ILLINOIS POWER COMPANY

Subject: Clinton Power Station Unit 1
SER Outstanding Issue #9
SER Confirmatory Issues #13, #71
Suppression Pool Hydrodynamics

The following are the NRC questions asked in the April 18, 1984 meeting with its corresponding response.

FIGURE 1.0

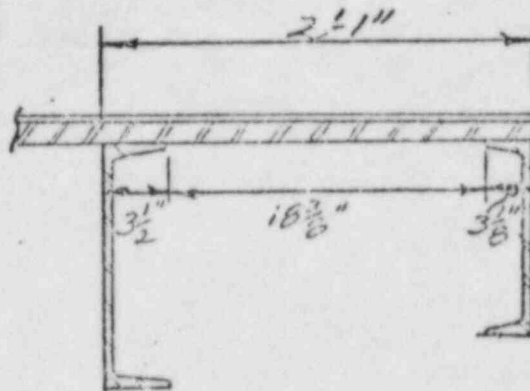
- a) Justify why CPS has used the pool swell shape, as predicted by the GE-performed SOLA analyses, to make modifications to the present encroachments (i.e., extending the existing structure further away from the drywell wall over the suppression pool).
- b) Justify the use of 115 psi as the impact load for beams used on the 737' elev. floor extension over the suppression pool.

- a) Illinois Power has transmitted the justification for the encroachment extension as part of the Humphrey Issues. (Reference Letter U-0714, D. I. Herborn (IP) to A. Schwencer (NRC), dated May 25, 1984). As a member of the Containment Issues Owners Group, (CIOG), Illinois Power's involvement to resolve the validity of SOLA is still in progress.
- b) The encroachment modification at 737'-0" elev. of the containment has been designed for a 115 psi impact load. The exposed surfaces of the encroachment's S-sections, C-sections, and the plates supported by the C-sections are illustrated in Figure 1.0 (attached). As shown, all the widths of these exposed sections are less than 20". Therefore, these sections were designed to the load definition of "small structures," which is 115 psi.
